**RE: NATIONAL GRID**

ILION (EAST STREET) SITE, SITE NUMBER 6-22-019

REVISED SUPPLEMENTAL RI WORK PLAN

Supplemental Remedial Investigation Work Plan

Proposed Soil Vapor Points — Site Supplemental Remedial Investigation Work Plan Ilion (East Street) Site

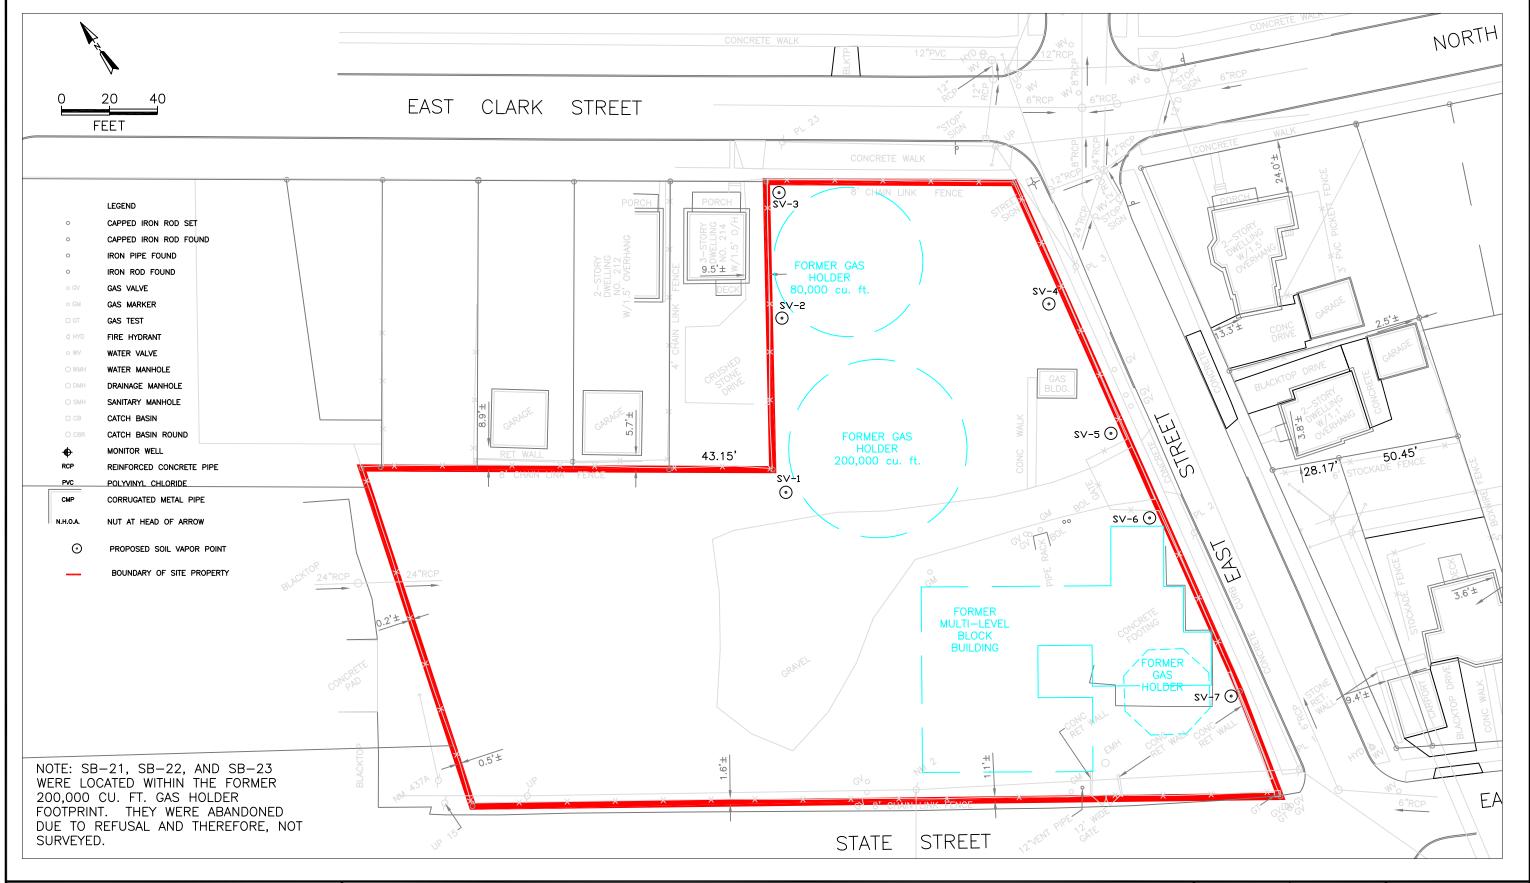
The work plan indicates that the soil vapor samples will be analyzed by USEPA Method TO-15 for the analytes described in the National Grid SOP. Again, it should be known that this document has not been approved by the agencies, however the list identified in the SOP appears to contain contaminates of concern for this site, therefore the TO-15 list in National Grid's SOP will address contaminates identified for this site. Sample point SV3 should be moved to be collected immediately north of the former 80,000 cu. Ft. holder in the northwest corner of the site along East Clark Street (inline with proposed SV1 and SV2 – Figure 1).

The Work Plan has been revised to refer to the approved appendices from the National Grid SOP. In addition, Figure 1 has been revised as suggested – the location for SV3 has been relocated to be in line with SV1 and SV2.
